SERVICE BULLETIN

DATE: March 13, 2019 Service Bulletin No. 622A
 (Supersedes Service Bulletin No. 622)
 Engineering Aspects are
 FAA Approved

SUBJECT: Reprint of Slick/Champion Aerospace Service Bulletin SB1-15A
MODELS AFFECTED: All Lycoming engines equipped with Slick 4200, 4300, or 4700 Series (LASAR) magnetos.

Figure 5. K3008 Distributor Gear With Monel Electrode

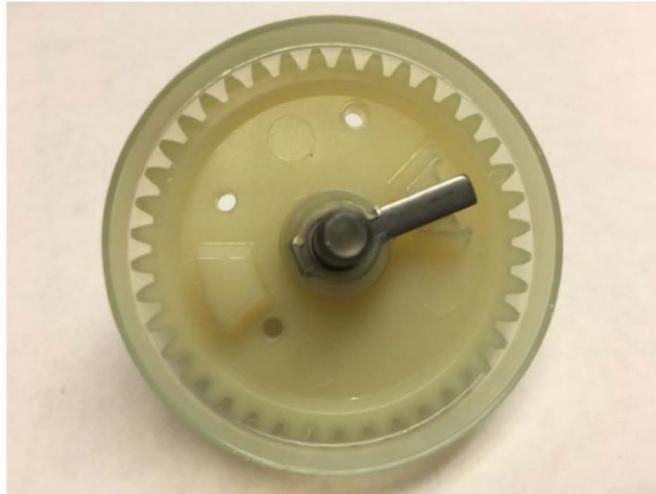
If it is not possible to confirm the version of the distributor gear that is installed in a given magneto from maintenance records, the magneto may be removed from the engine in order to have the housing and distributor block removed to allow visual inspection of the distributor gear. Distributor gears with Copper electrodes must be replaced with distributor gears with Monel electrodes.

REMOVE K3008 distributor gear assembly in subject magnetos and REPLACE with replacement K3008 distributor gear assembly **as soon as possible**, not to exceed the next 50 hours.
